From: Wendi Hundley [REDACTED]  
Subject: CRCRC Feedback  
Date: May 31, 2024 at 12:54:19 PM CDT  
To: [CRCRC@rollingwoodtx.gov](mailto:CRCRC@rollingwoodtx.gov)  
Cc: Desiree Adair <dadair@rollingwoodtx.gov>, Ashley Wayman <awayman@rollingwoodtx.gov>, nstautz@rollingwoodtx.gov

I've been reviewing the proposal and trying to understand its language and intent, and applying it to my own property to see how it works in real life. I've noticed a bit of a mismatch between the verbal explanations, written descriptions, and illustrations. For example, during the last meeting, you demonstrated creating the lower plane using bent paper to mimic the hill on my lot (which is actual topography where it is higher in the middle and the two adjacent sides are lower) but some of the provided examples show a straight line drawn from the highest to the lowest elevation, while others show the grade. Additionally, it was discussed that for my property I should take the actual topography grades and measure from the interior lower floor (minus the basement) to get the height of the ridgeline. I didn't see language explaining this in the draft, so it was confusing to determine where to measure the ridgel

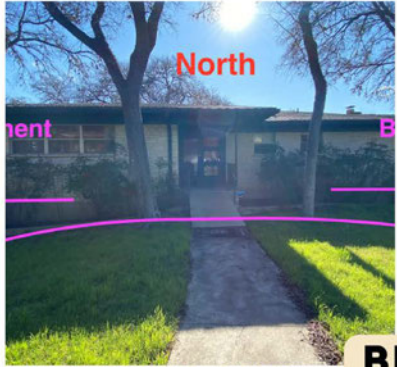
After the meeting, I reviewed the topo measurements and found that my house is slightly off when including the basement. Without the basement, it works. With the basement, I'm about 3 feet too tall.

- Scale: 1mm = 1.5774'
- Lower Finished Floor: 546.54'
- Grade beneath the Ridgeline: Approx. 548'
- Reference Datum: 555.34'
- Ridgeline: 584.46'
- 35' Height Limit from Reference Datum: 590.34'
- Height from Ridgeline to Grade Beneath Ridgeline: 36.64'
- Height from Ridgeline to Finished Floor: 37.99'
- Height from Ridgeline to Imaginary Plane in "Basement": 31.83'

Aside from trying to understand, I do have some concerns about equity for sloped lots that I think can be solved. I continue to ask if under the proposed rules, a home like mine can be allowed to be built, if the previous house didn't have a basement garage but instead had a foundation. I asked if the word "existing" in front of basement was meant to grandfather properties or if the word "existing" could be modified to allow for some kind of subterranean basement in new builds. Maybe it could be considered that instead of saying "existing basement," it could be defined to allow such a design in new builds under specific circumstances. I also wonder why the language includes man-made features like pools and basements alongside natural formations. These likely need different treatments.

**BEFORE**

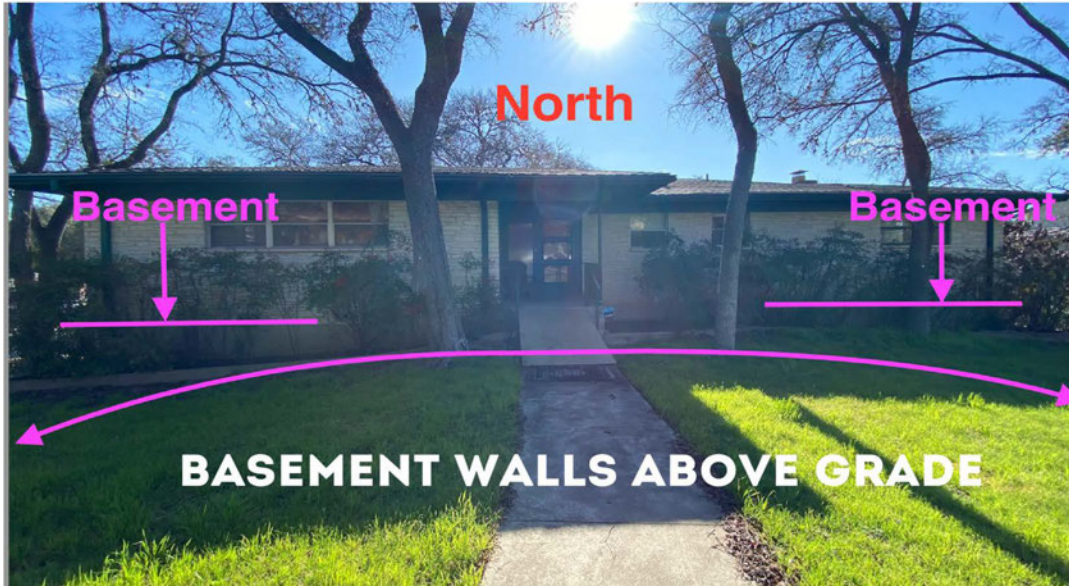
The previous home on my lot had a daylight basement on three sides, and in addition the top part of the basement wall in the front of the house stuck up above the highest grade. In the front, my lot slopes down from the middle on both sides and also from front to back. I've included some photos to help show our former daylight basement and have included both interior and exterior photos, which may help illustrate why we consider it to be basement space. I am sending these in case they might be helpful to you as you consider possible definitions for basements in the future.
